AMENDED PLANS APPROVED

REGISTERED PROFESSIONAL ENGINEER QUEENSLAND						 info@patcol.com.au www.patcol.com.au 186 Denham Street, Rockhampton QLD 4700		DAVID BELL		LOT 69,10 CHAPPELL STREET, KAWANA, QLD	
RPEQ NO: 16203								GENERAL ARRANGEMENT SITE PLAN - AS BUILD			
SCOTT MATTHEW THOMAS											
SIGNATURE: 											
DATE: 04.09.26

DAVID BELL
LOT 69,10 CHAPPELL STREET, KAWANA, QLD
STORMWATER SITE PLAN – AS BUILD

Development Stormwater Management Report

GENERAL ARRANGEMENT SITE PLAN - AS BUILD
SCALE 1:150

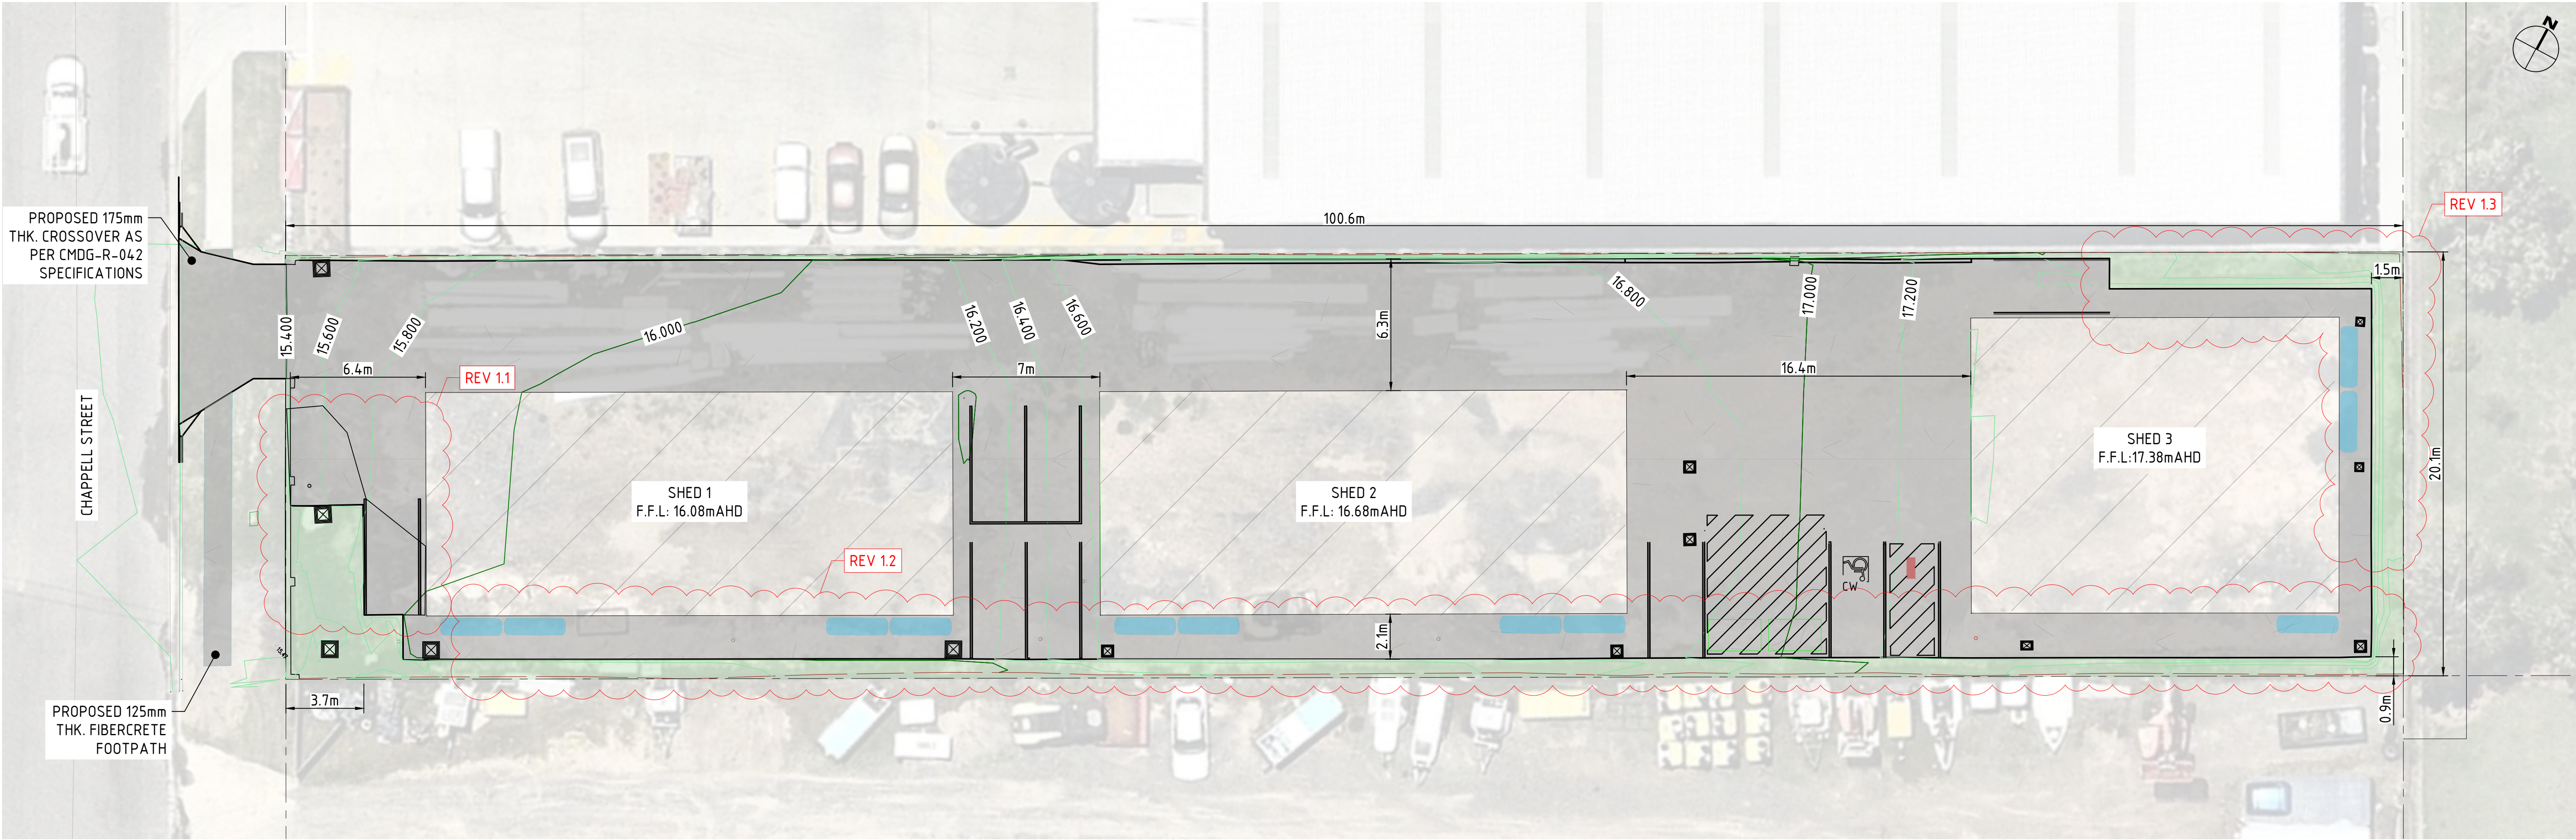
ITEM	DESCRIPTIONS
REV 1.1	26.5m ² PERVIOUS AREA HAS BEEN CONVERTED TO IMPERVIOUS AREA
REV 1.2	175.2m ² PERVIOUS AREA HAS BEEN CONVERTED TO IMPERVIOUS AREA, BIN STORAGE LOCATION AND CARPARK LAYOUT HAS BEEN REVISED
REV 1.3	39.0m ² PERVIOUS AREA HAS BEEN CONVERTED TO IMPERVIOUS AREA

STORMWATER SITE PLAN – AS BUILD
SCALE 1:150

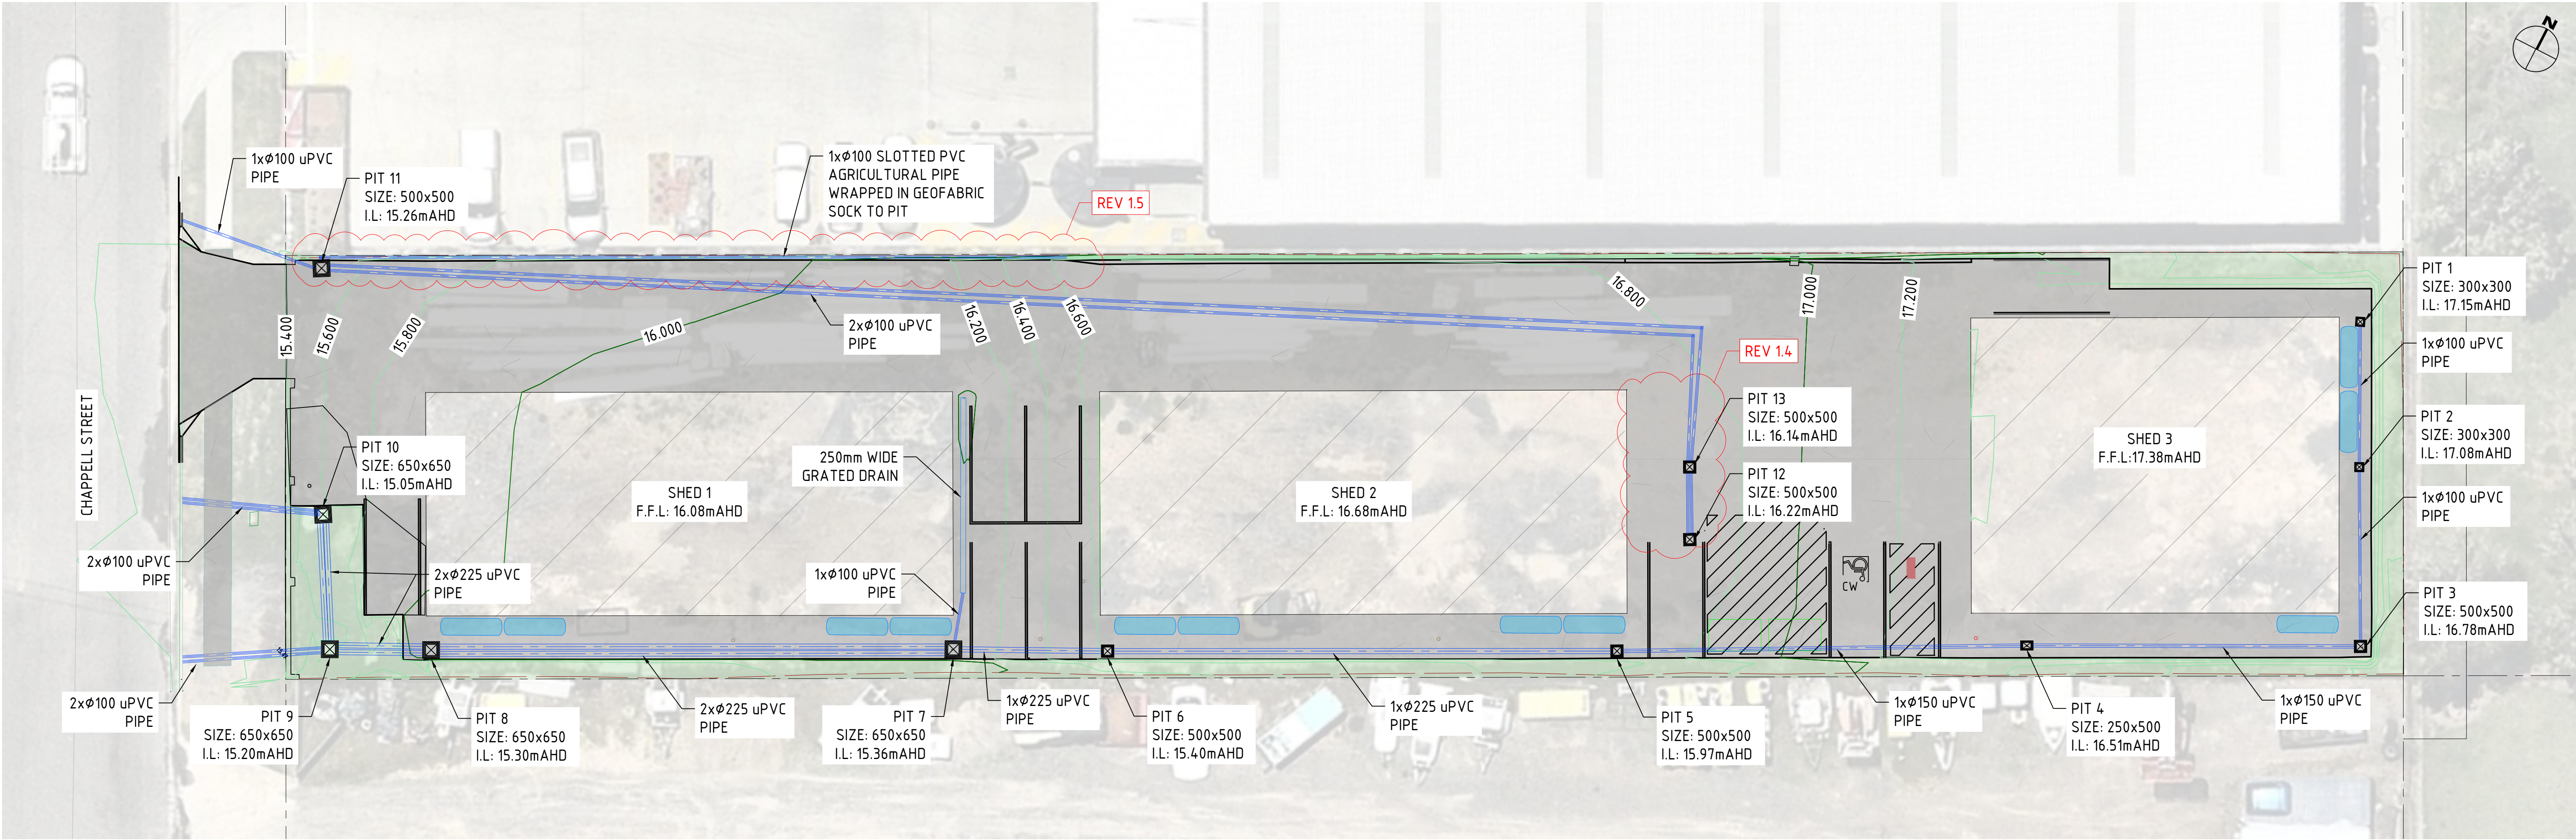
ITEM	DESCRIPTIONS
REV 1.4	TWO PITS HAS BEEN INSTALLED TO CAPTURE THE RUNOFF FROM THE CARPARK AND FURTHER DISCHARGE TO KERB AT CHAPPELL STREET.
REV 1.5	21.8m ² IMPERVIOUS AREA HAS BEEN CONVERTED TO PERVIOUS AREA, Ø100 AGG. PIPE HAS BEEN INSTALLED TO CAPTURE THE RUNOFF FROM THE DRIVEWAY AND FURTHER DISCHARGE TO KERB.
